IMPORTANT SAFETY RECALL

Airstream Travel Trailer

NHTSA Recall Number 17V-044

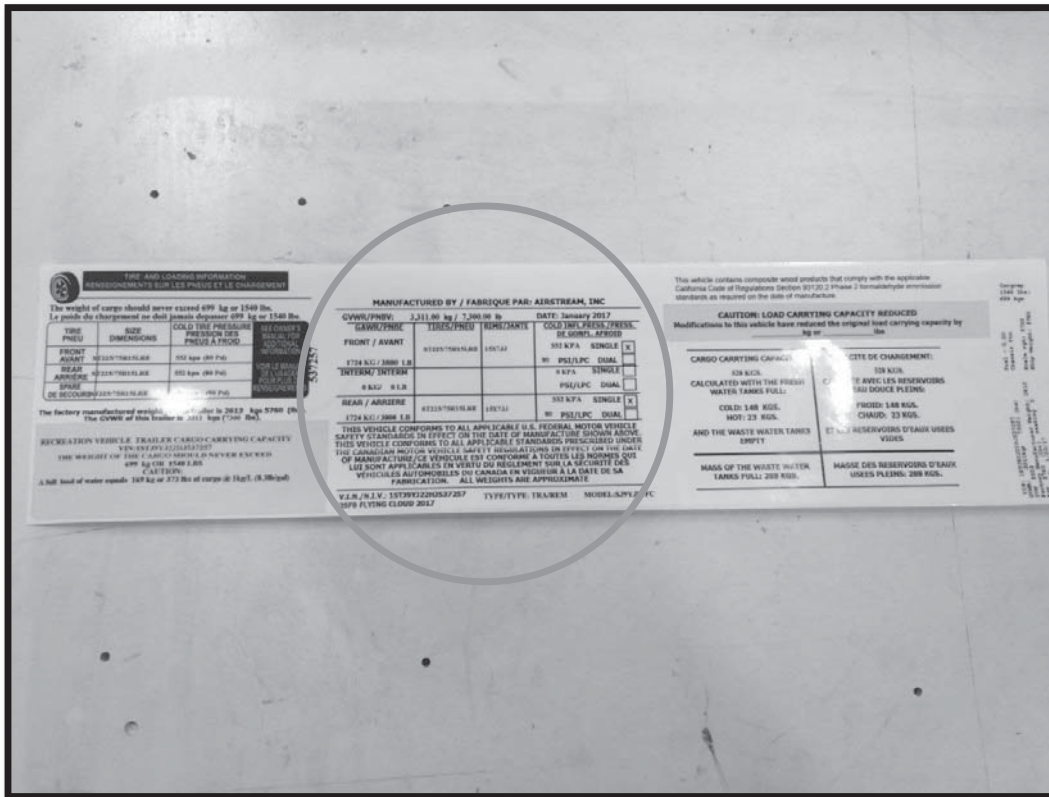
The affected travel trailers covered in this recall have incorrect tire information printed on the Federal Certification Label and Tire Placard.

Step 1: Start by locating the labels that need to be changed. They will be on the roadside (driver's side) of the vehicle near the rub rail.

Step 2: Wipe directly over the existing labels with the denatured alcohol to clean the area.

Step 3: Remove the new "Manufactured By" label first and place it over the same label on the trailer.

Step 4: Remove the new “Tire and Loading Information” label and place it over the same label on the trailer. You can discard the rest of the labels.
